Proposal Number: 2021-OA-001

**The OESC 28th Edition
Proposals for Ontario Amendments**

Specification 35
Details of secondary service rack ~~or neutral spool~~
[See Rule 75-406 1) a) and Appendix B Note to Rule 6-112 1).]

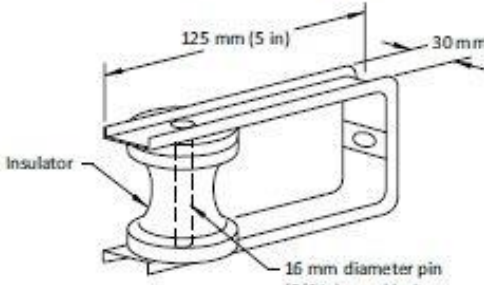
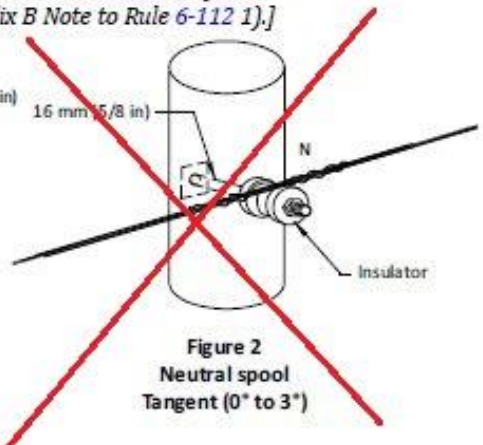
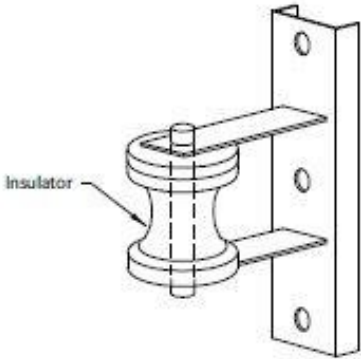
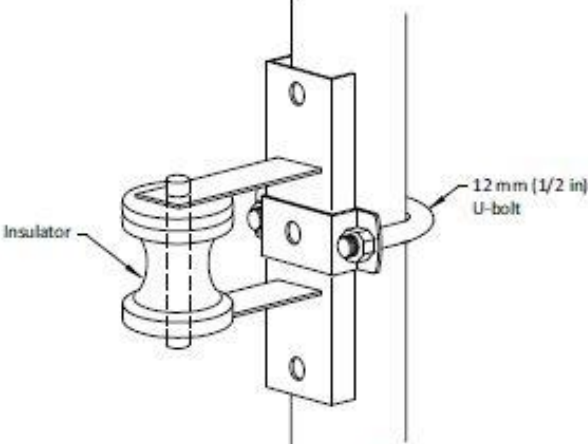
Revised Rule and Specification 35 and added new Specification 35.1 to identify attachment methods on poles.

Rule now recognizes neutral conductor attachment methods on poles. Figure 2, neutral spool attachment on pole moved to new Specification 35.1.

Specification 35.1 created to show the different neutral attachments on poles.

Figure B75-1 Central metering system- pad mounted installation

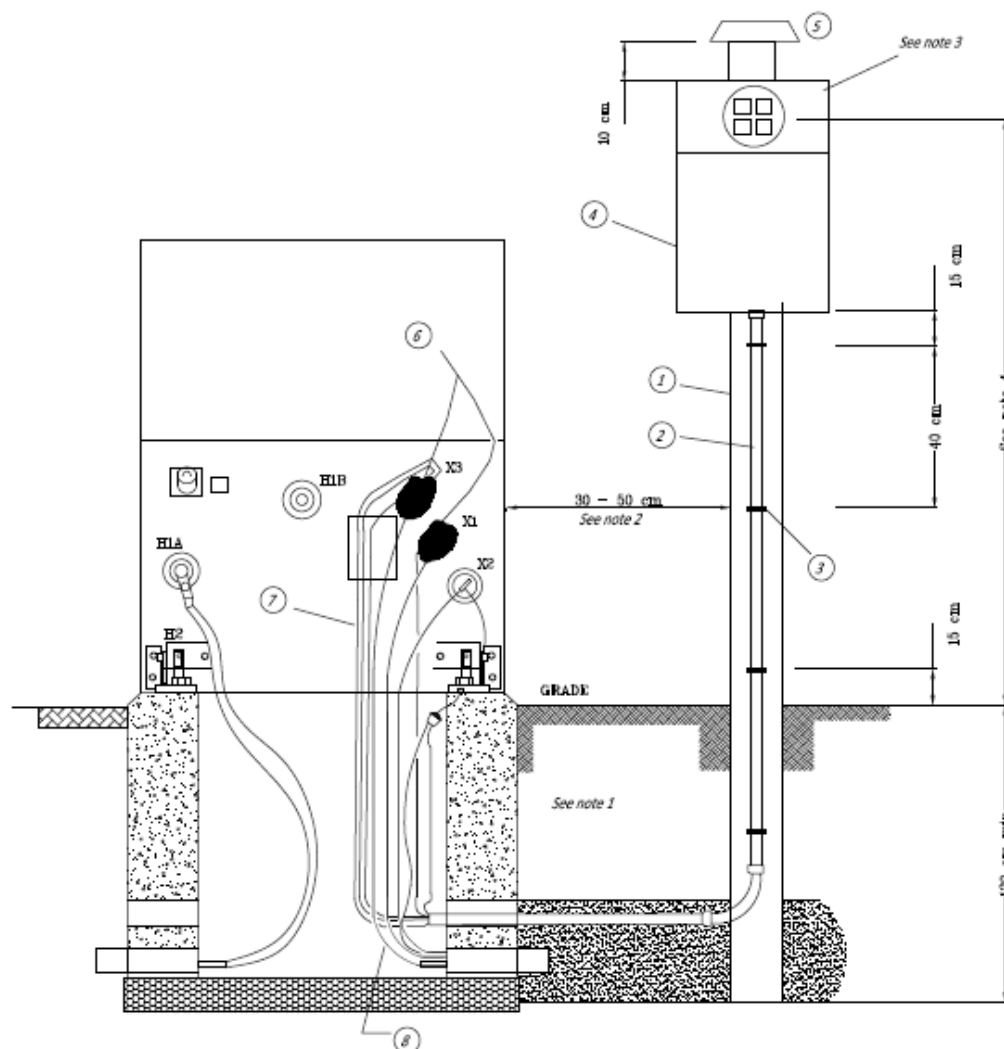
Description of Change: Revised Rule 75-902 to recognize ground mounted central metering systems.

Add new Appendix B 75-902 g) as follows:

Description of Change: Revise current Ontario Amendment Specification 34 to include other grounding electrodes

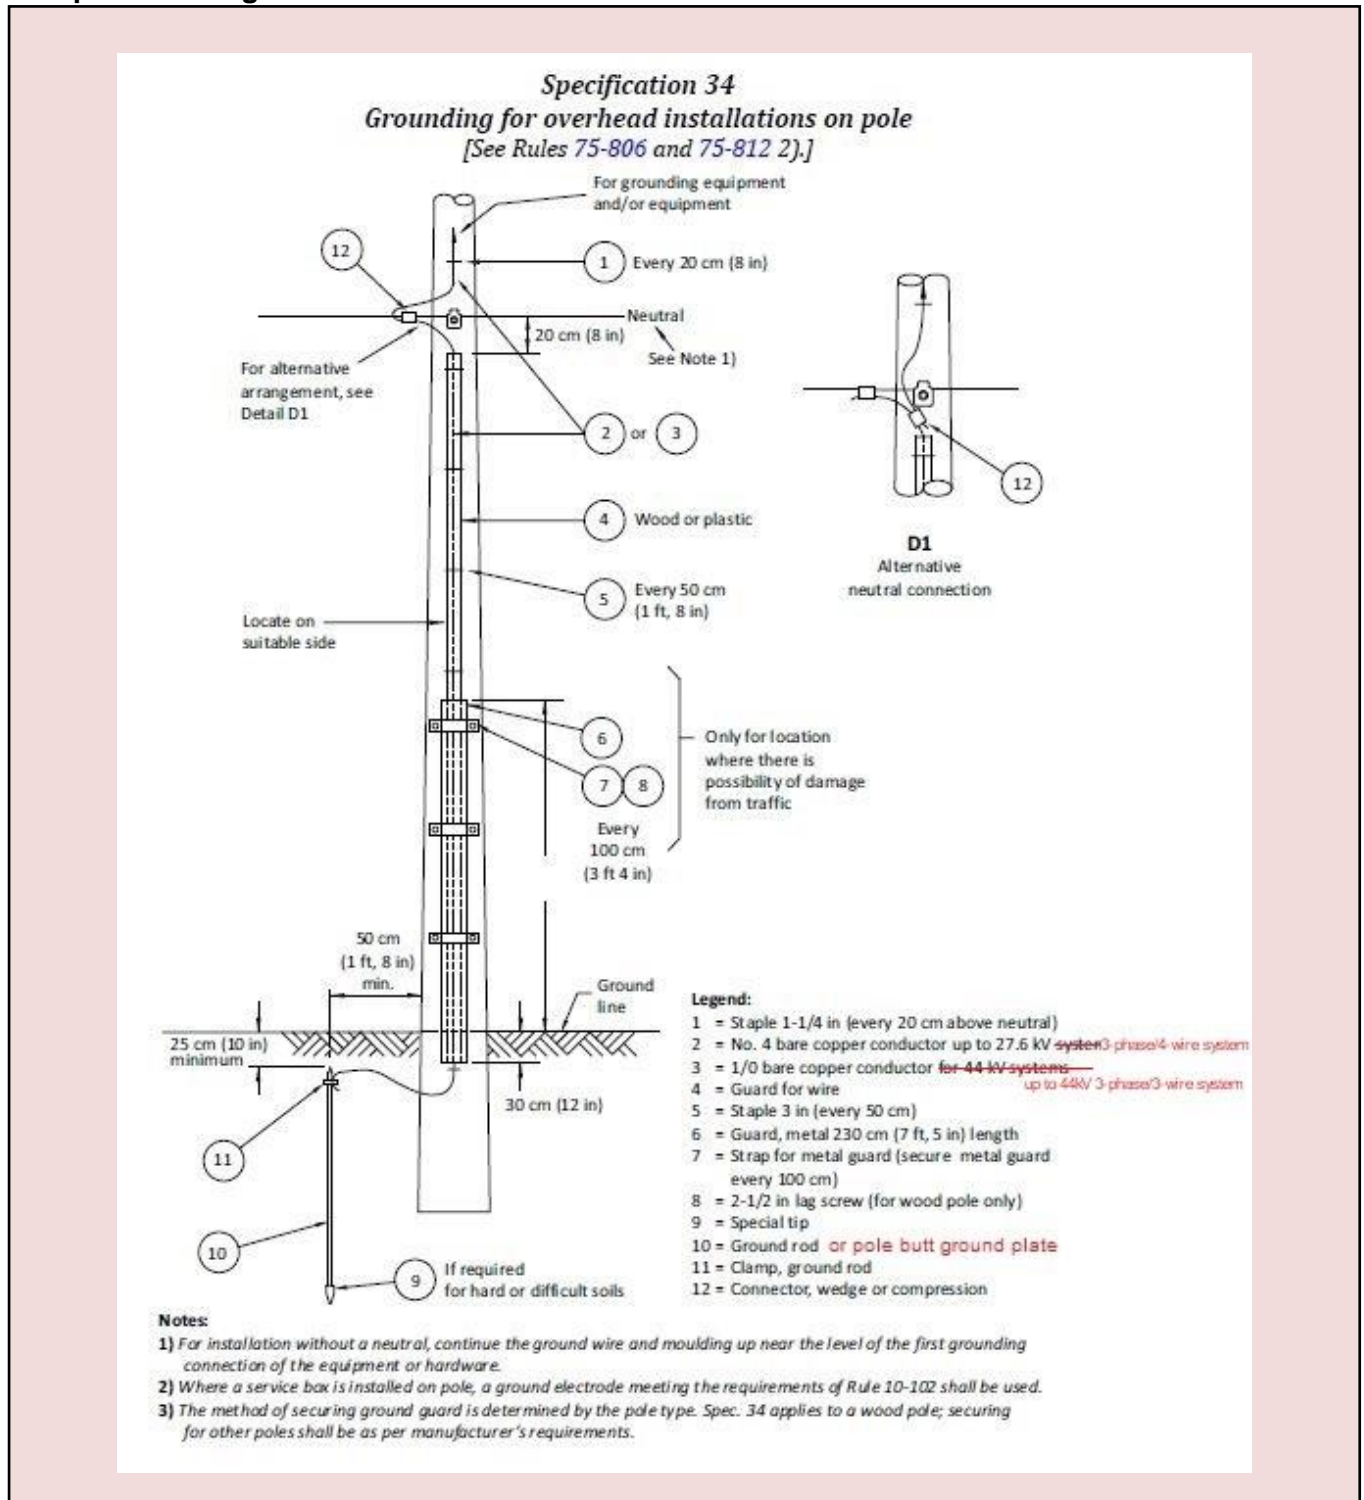
Revised specification to include pole butt plates and general revision

Revised item number two to clarify the grounding conductor size for primary voltages up to 27.6kV 3-phase/4-wire systems.

Revised item number three to include 3-phase/3-wire systems for primary voltages up to 44kV. Other voltages such as 27.6kV can be distributed as ungrounded.

Revised item number ten to now include pole butt ground plates. Ground electrodes are manufactured to meet the requirements of CSA C22.2 No.41 as identified in Appendix B note for Rule 10-102.

Specification 45

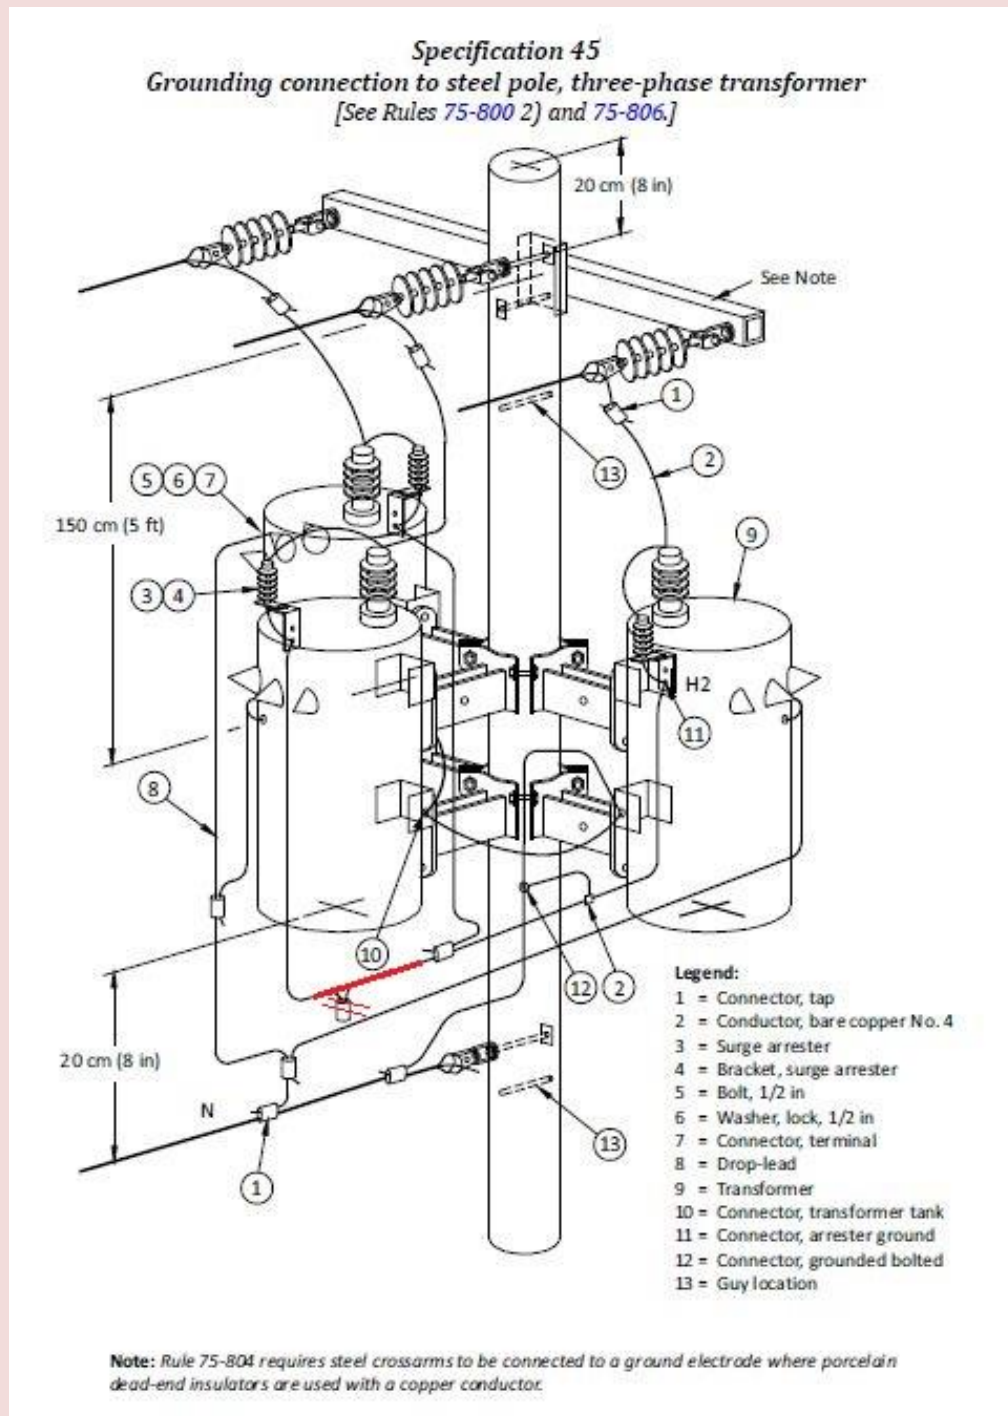
**Description of Change: Revise current Ontario Amendment Specification 45-
editorial**

Editorial revision to remove crimped connector. This was missed on the previous code edition during the file conversion.
